DOCUMENT 00 90 00
ADDENDUM

ADDENDUM: 2

PROJECT: WESTERN TECHNICAL COLLEGE
SPARTA PUBLIC SAFETY TRAINING SIM CITY
11177 COUNTY HWY 1
SPARTA, WISCONSIN 54656
PROJECT NO. 25039

FROM: HSR Associates, Inc
100 Milwaukee Street
La Crosse, WI 54603
(608) 784-1830

Project Title: **WTC SPARTA PUBLIC SAFETY TRAINING SIM CITY**
HSR Project Number: **25039-1**
Project Date: **FEBRUARY 2026**
Drawn By: **POB**
Key Plan:
Project Location: **11177 COUNTY HIGHWAY A
SPARTA, WI 54666**
Sheet Title: **GRADING PLAN-SOUTH**

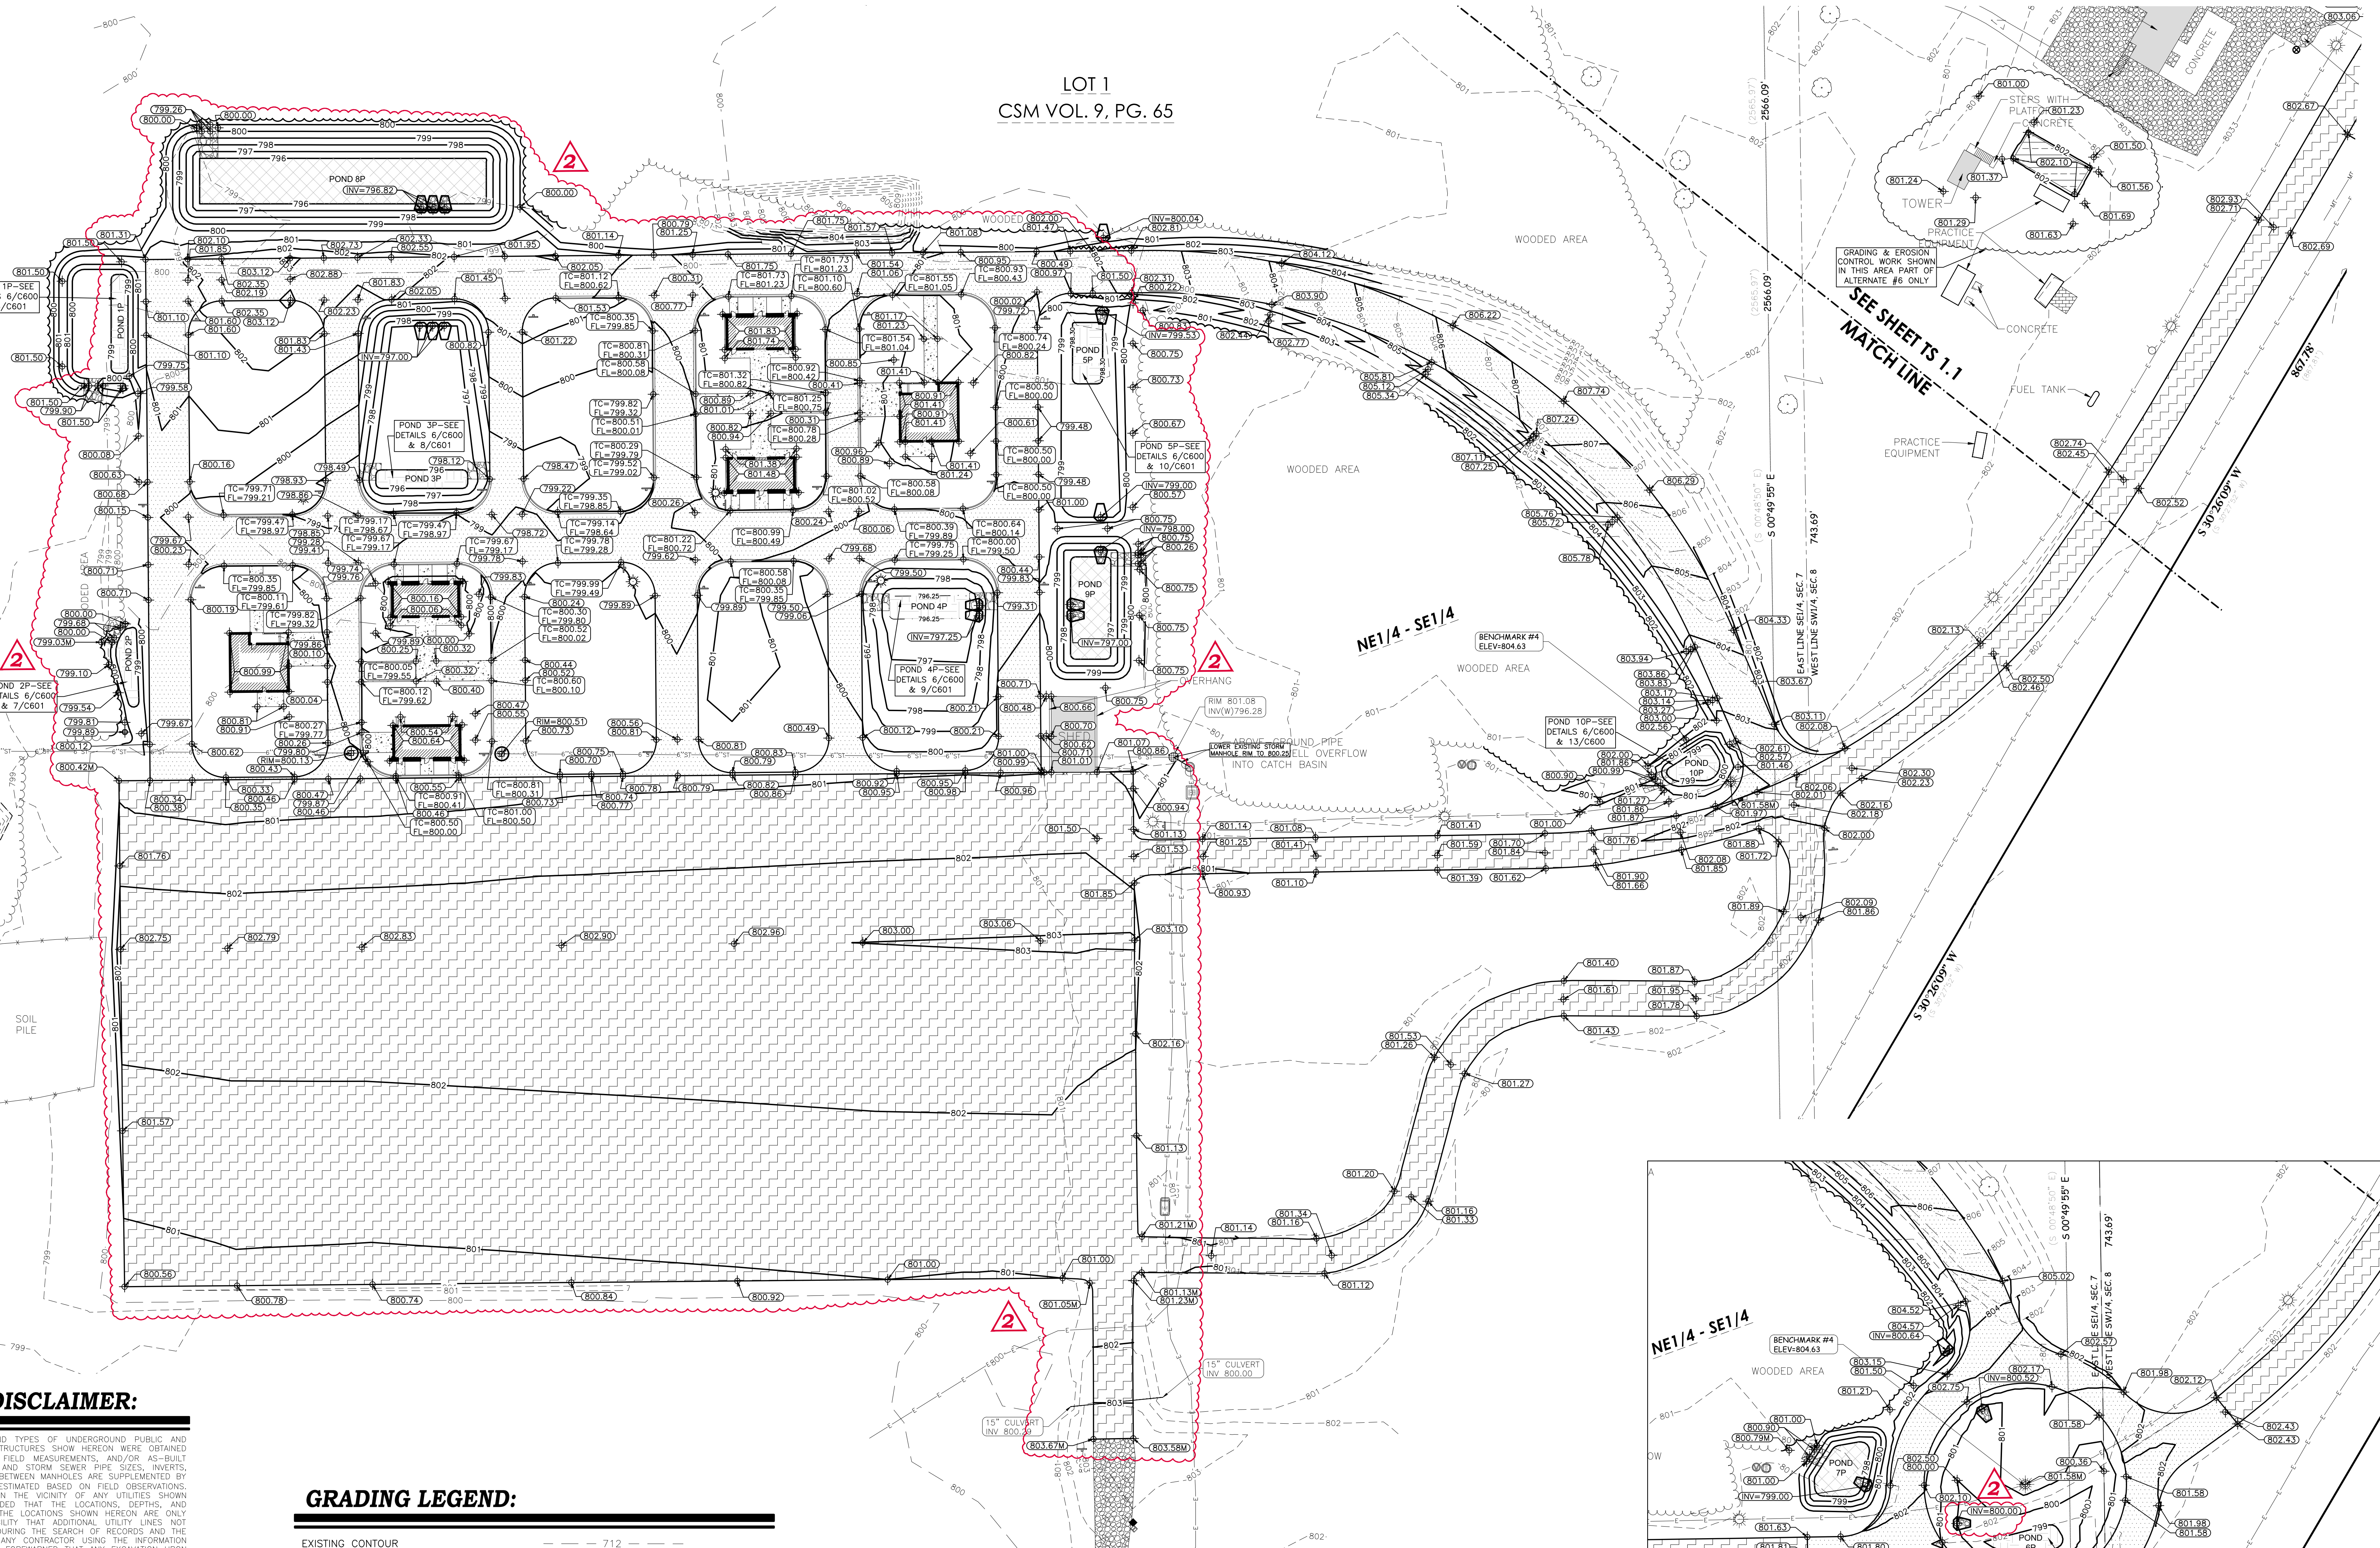
- a. See the revised sheet included in this addendum. Disregard the previous version.
- b. Added detail reference to "Proposed Rip Rap Area".
- c. Revised invert elevation of endwall in roundabout green space.
- d. Revised grading within alternate #3 paving area.
- e. Revised grading within "Sim City" paved areas, building finish floors, and green space areas. The intent is to maintain elevation of the northern pavement edge in the event alternate #3 is not accepted. The new Sim City roadway pavement can match into the existing pavement elevation.

1
C400

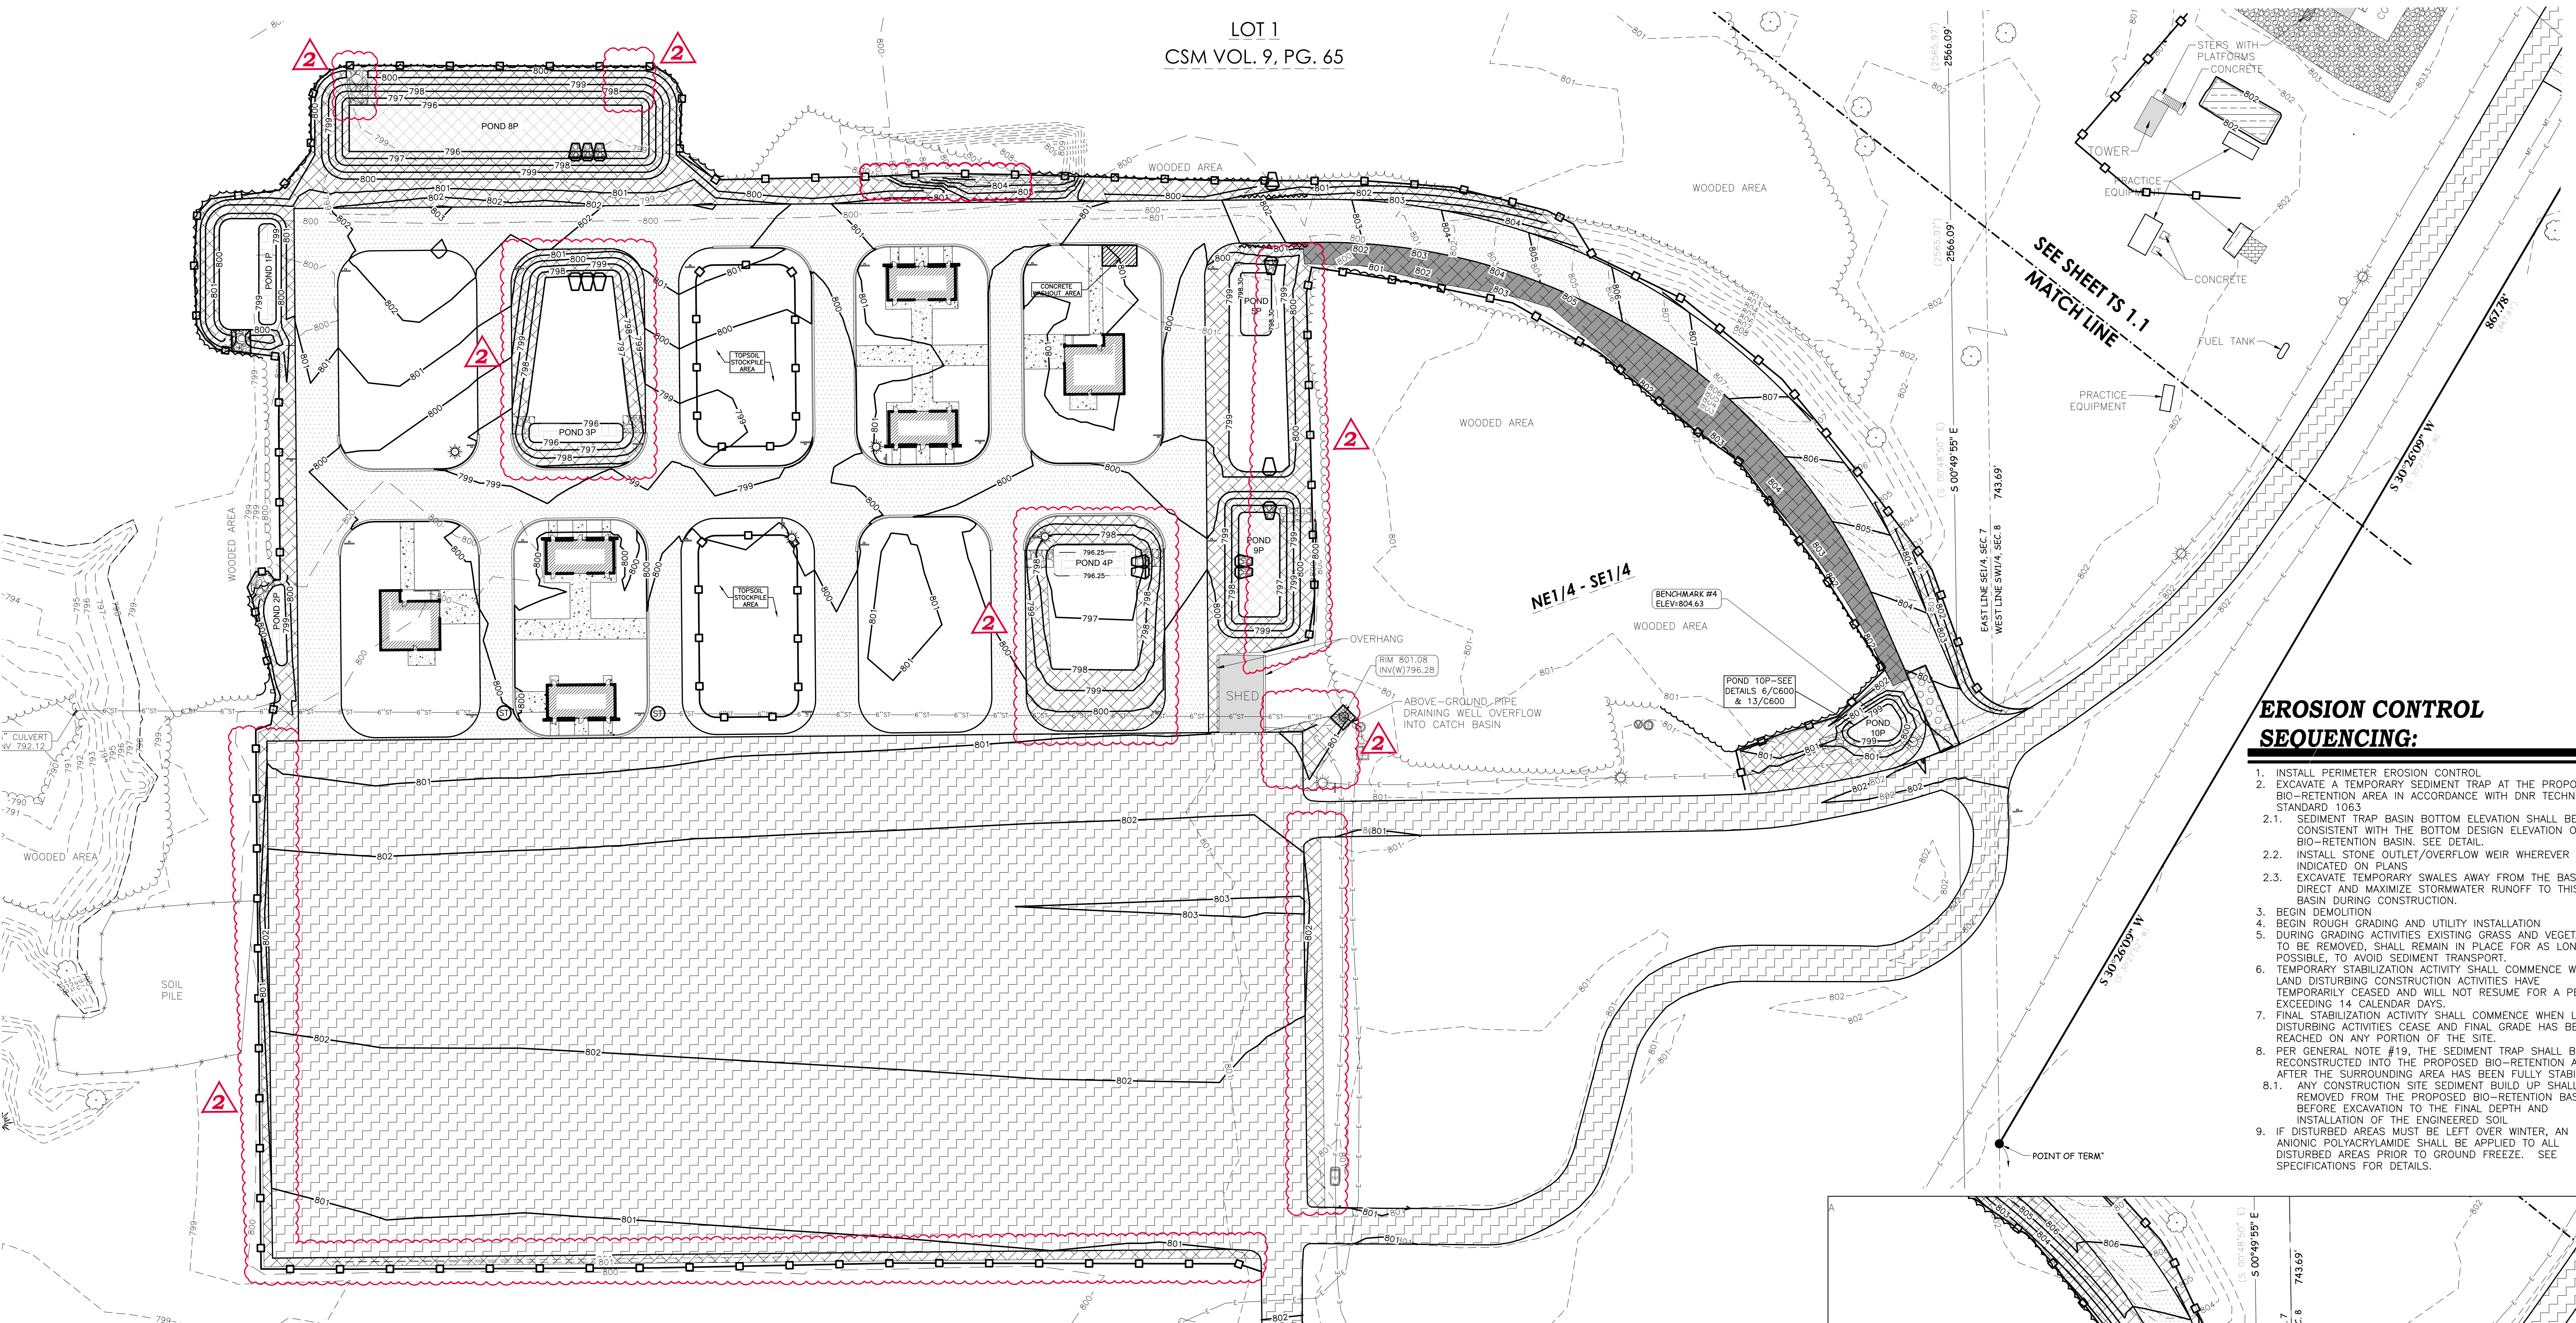
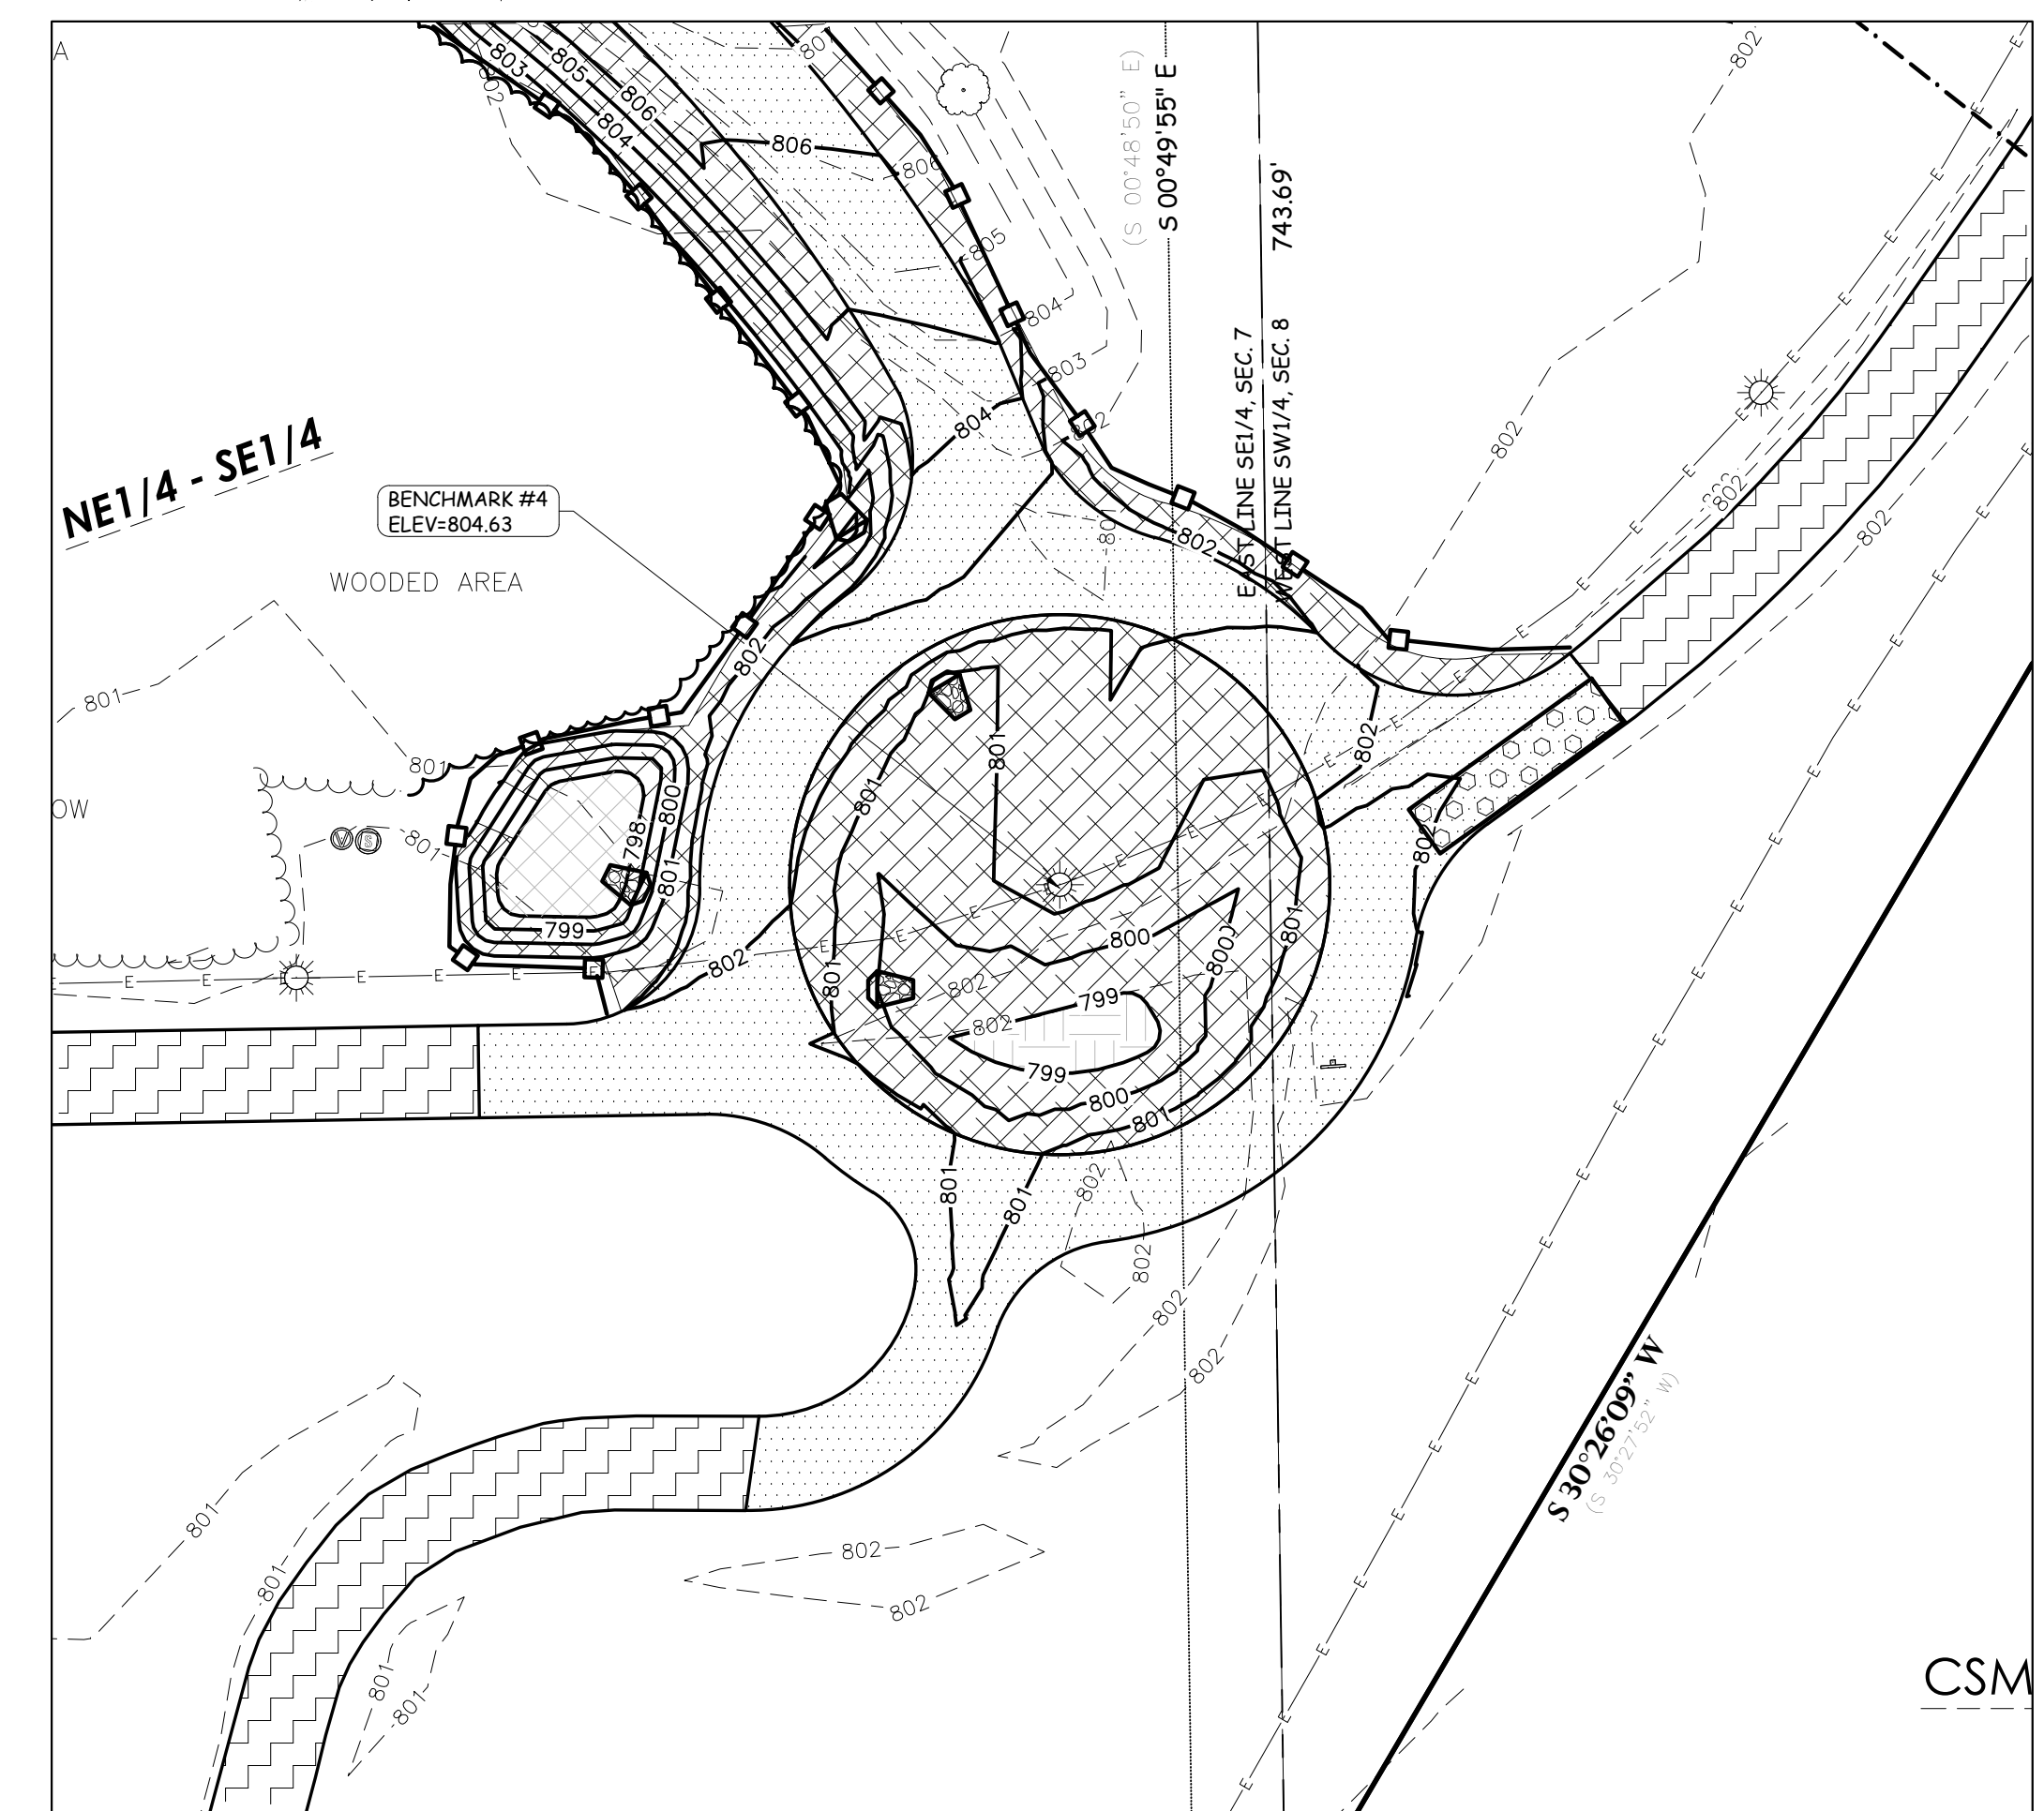
- a. See the revised sheet included in this addendum. Disregard the previous version.
- b. Added detail reference to "Rip Rap Area" in the Erosion Control Legend.
- c. Revised silt fence location on south and west side of alternate #3 paved area.
- d. Added silt fence to east side of alternate #3 paved area.
- e. Added erosion control blanket to northeast corner of alternate #3 paved area.
- f. Revised erosion blanket within green space lot (northwest).
- g. Revised erosion blanket within green space lot (southeast).
- h. Revised erosion blanket and silt fence locations east of ponds 9P and 5P.
- i. Revised location of rip rap overflow weir in pond 8P.
